Re: Response to Transportation Peer Review
Proposed Multifamily Residential Development – 444 East Central Street (Route 140)
Franklin, Massachusetts

Vanasse & Associates, Inc. (VAI) is providing responses to the comments that were raised in the May 30, 2025 *Transportation Peer Review* memorandum prepared by Howard Stein Hudson (HSH) concerning their review of the February 2025 *Transportation Impact Assessment* (the “February 2025 TIA”) that was prepared by VAI in support of the proposed multifamily residential development to be located at 444 East Central Street (Route 140) in Franklin, Massachusetts (hereafter referred to as the “Project”). Listed below are the comments that were identified by HSH in the subject memorandum pertaining followed by our response on behalf of the Project proponent. Where indicated, specific responses to the comments pertaining to the Site Plan will be provided by others under separate cover.

DRAWING TITLE: SU-30 TRUCK TURNING PLAN
SHEET NO.: C-107A

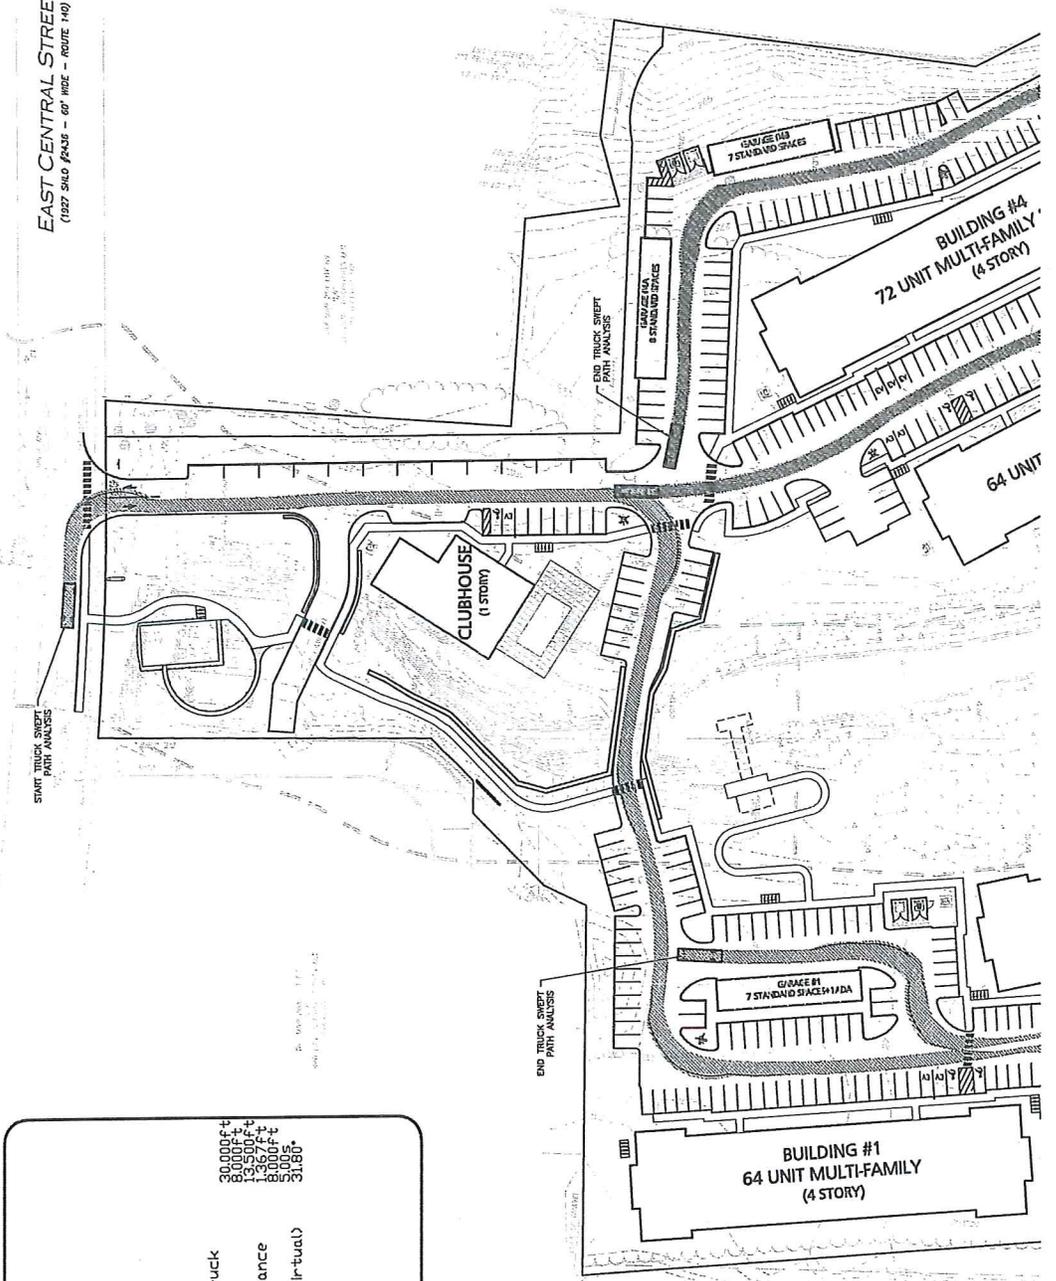
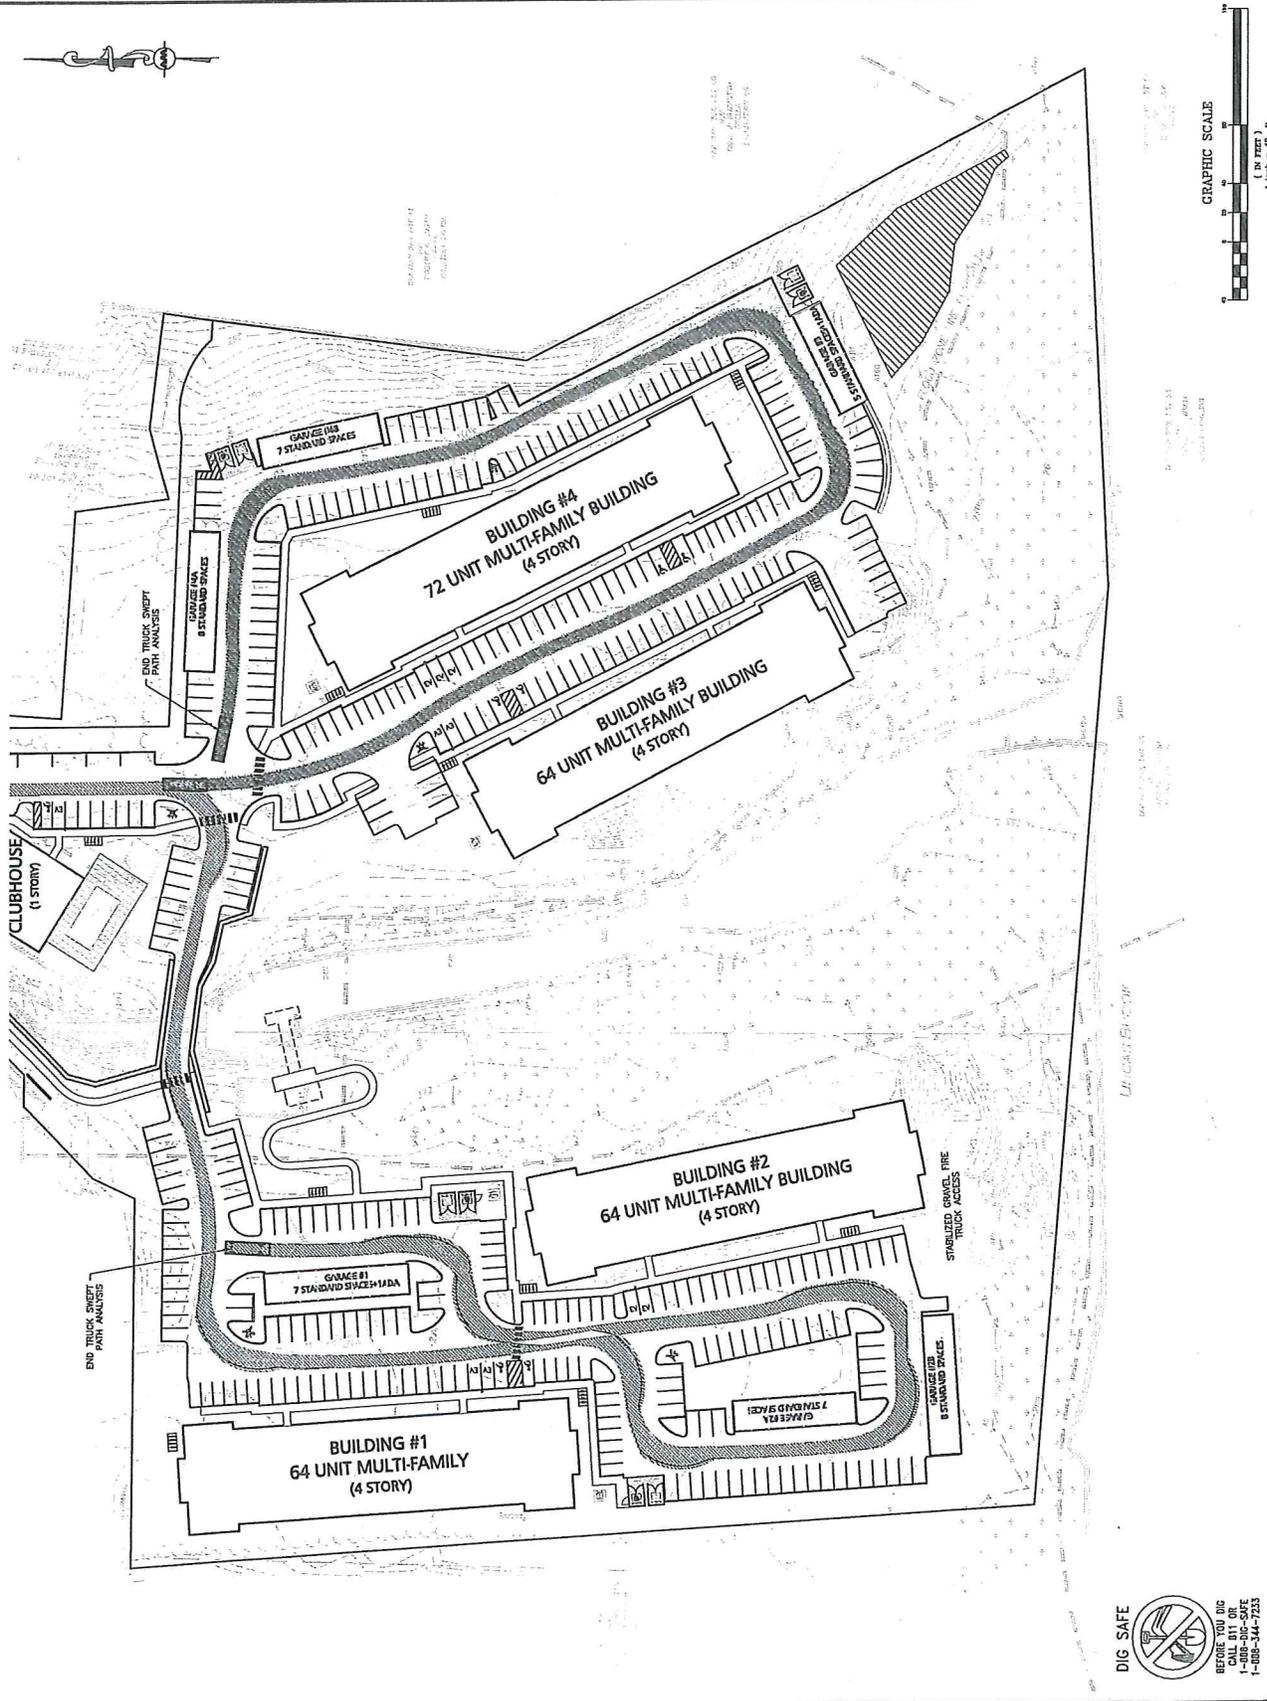
HSH Comment: *HSH acknowledge the delivery parking stall located across the clubhouse building; however, this delivery zone is designed for a typical delivery box truck (maximum 22-feet-long) for possible short-term deliveries. HSH requests the Applicant provide a detailed plan as to where move-in/move-out activity will take place, including an AutoTURN analysis to demonstrate that all anticipated vehicles (moving and delivery trucks) can safely access the Site. If the parking areas are anticipated for move-in/move-out activities, demonstrate that moving vehicles will not block drive aisles while parked.*

Response: Tenant moves will be coordinated with the property manager and will be required to be scheduled in advance. Moving vehicles will be staged in parking spaces proximate to the building entrance and will be reserved by placing cones or otherwise cordoning off the space(s) to be used. A vehicle turning analysis for a moving van (SU-30) has been prepared by Allen & Major Associates, Inc. (A&M) as a part of the revised Site Plan that depicts the typical moving condition for each building and is included as an attachment.

Figure 1P

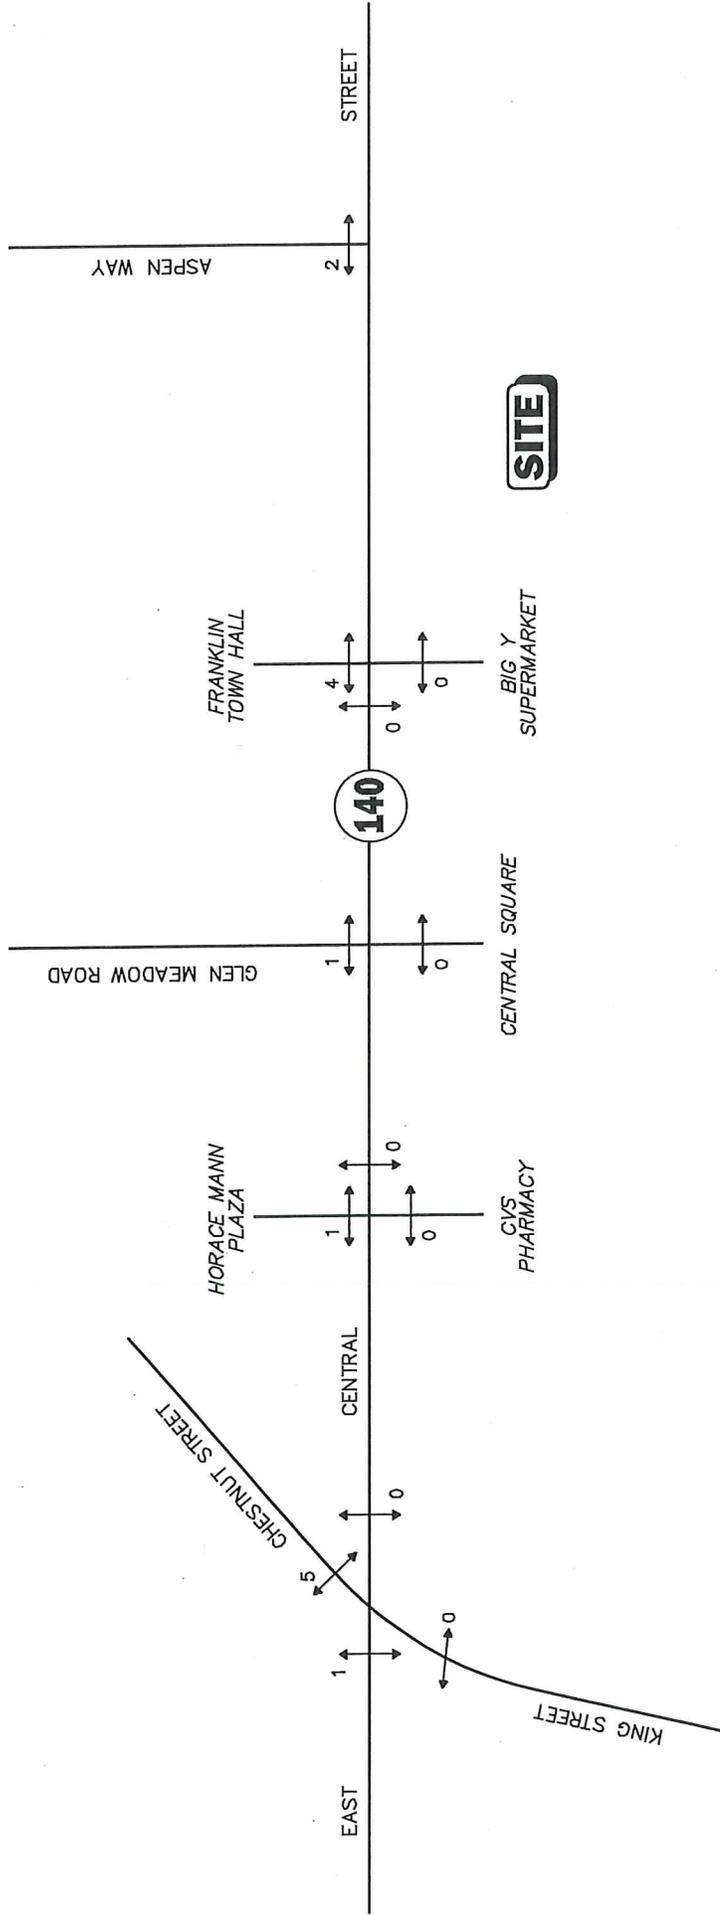
HSH Comment: *HSH generally agrees with the proposed pedestrian facilities including the five-foot-wide sidewalks around the Site as shown in the submitted plan; however, to better understand the existing foot traffic along Route 140, HSH requests the Applicant provide a summary of the existing pedestrian volumes, with figures, at the study area intersections.*

Response: Figures 1P, 2P and 3P summarize the pedestrian volumes observed at the study area intersections during the weekday morning, weekday evening and Saturday midday peak hours as observed in December 2024 as a part of the TMCs that form the basis of the February 2025 TIA. As shown thereon, pedestrian activity within the study area was relatively low, ranging from one (1) to eight (8) pedestrian crossings, with the majority of the observed pedestrian crossings occurring at the Route 140/Chestnut Street/King Street intersection followed by the Route 140/Horace Mann Plaza/CVS Pharmacy driveways intersection. It is likely that pedestrian activity within the study area is higher during the more seasonable months of the year.

LAYOUT & MATERIALS PLAN

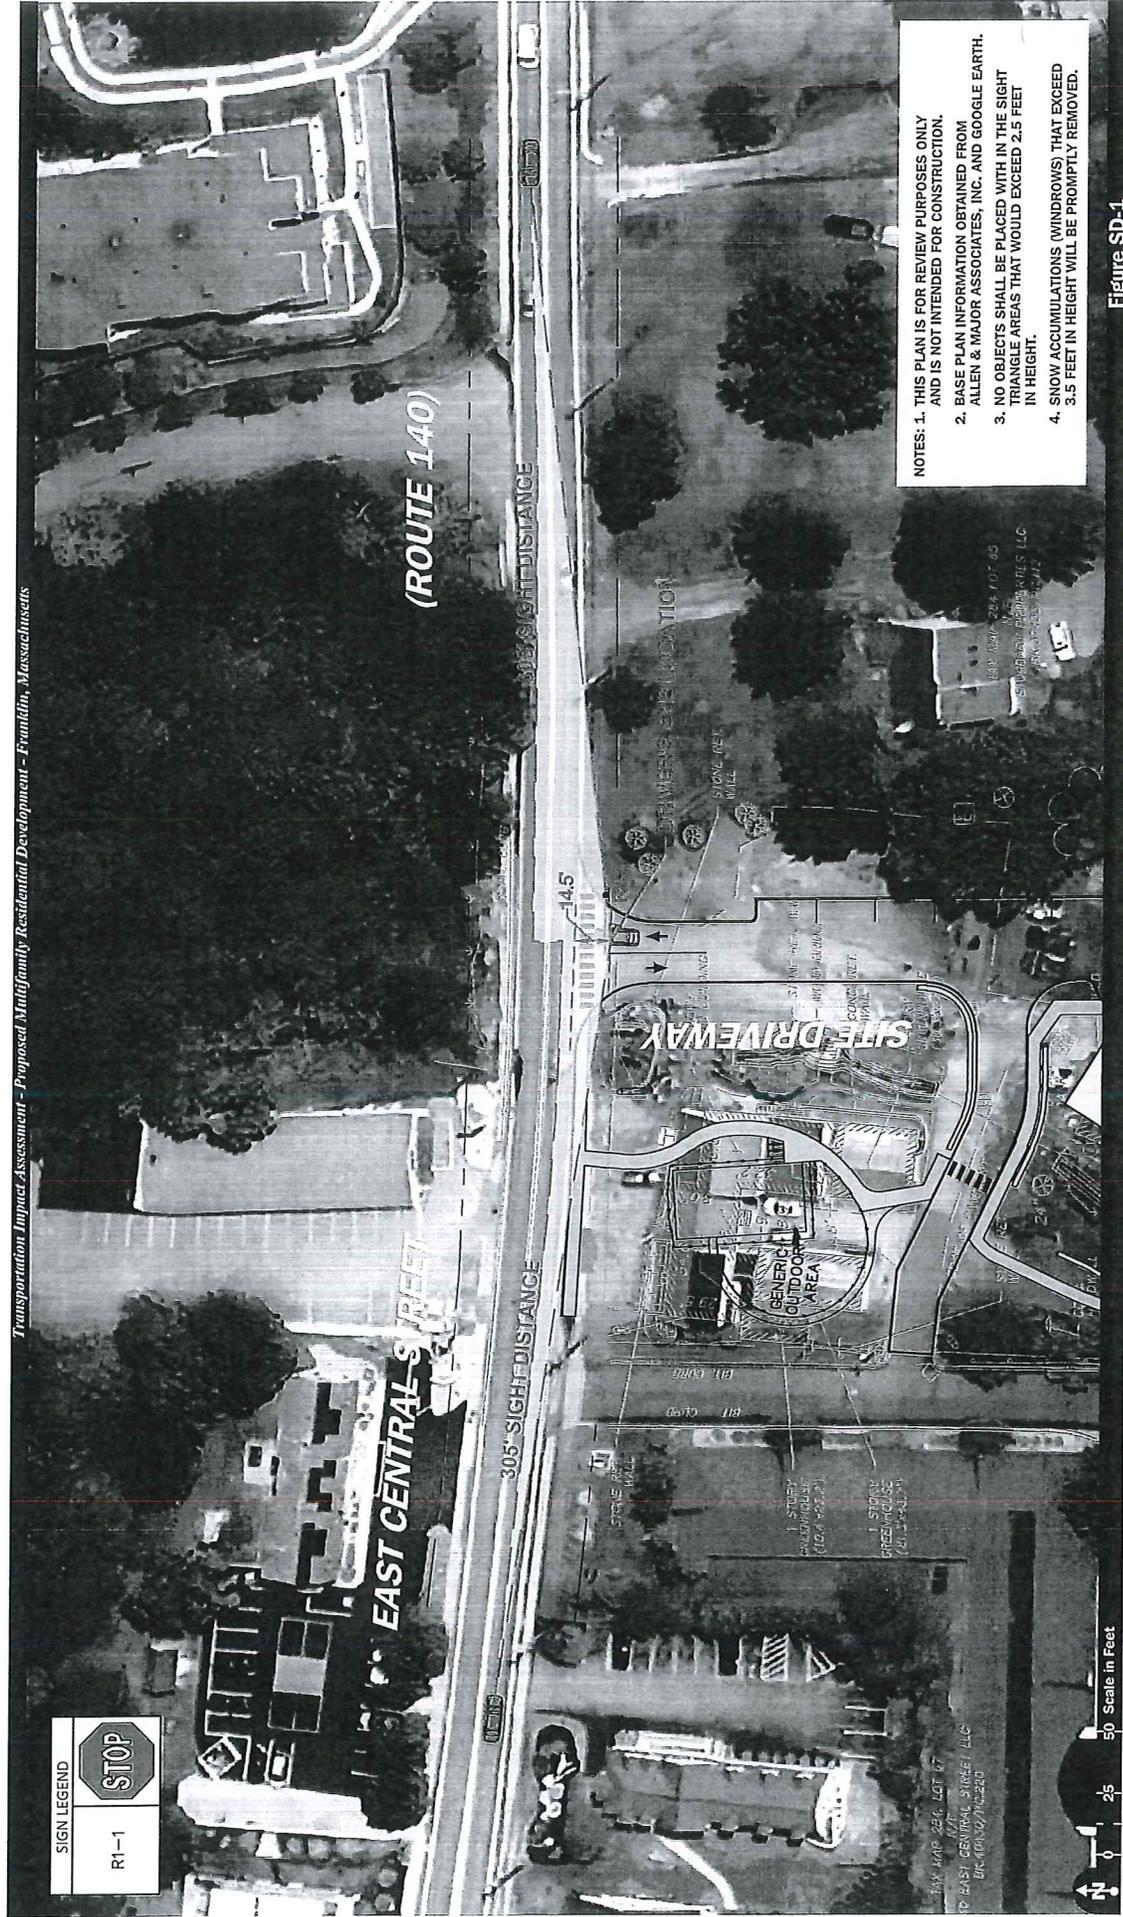
HSH Comment: *Bicycle parking areas are not shown in the plans. HSH requests the Applicant confirm the number of secure bicycle parking spaces and the number of exterior bicycle racks that the Project will provide and submit a revised site plan to confirm the location of these bicycle parking areas.*

HSH Comment: HSH generally agrees with the proposed TDM measures; however, the pick-up/drop-off zone for carshare was not located on the submitted plans. HSH requests the Applicant provide more information of this zone within the project site. HSH also requests the Applicant confirm how many parking spaces will be designated as EV charging stations spaces and recommends these stations be assigned to each building. Lastly, HSH requests the Applicant also confirm the number of secure bicycle parking spaces and the number of exterior bicycle racks that the Project will provide, and submit a revised site plan to confirm the location of these bicycle parking spaces.

Response: The Site Plan has been updated to include the location of bicycle parking within the Project site. Sixty (60) bicycle parking spaces will be provided within the Project site. The Layout & Material Plan from the revised Site Plan are attached.

The Site Plan has been updated to include the location of bicycle parking within the Project site. Sixty (60) bicycle parking spaces will be provided within the Project site. The Layout & Material Plan from the revised Site Plan are attached.
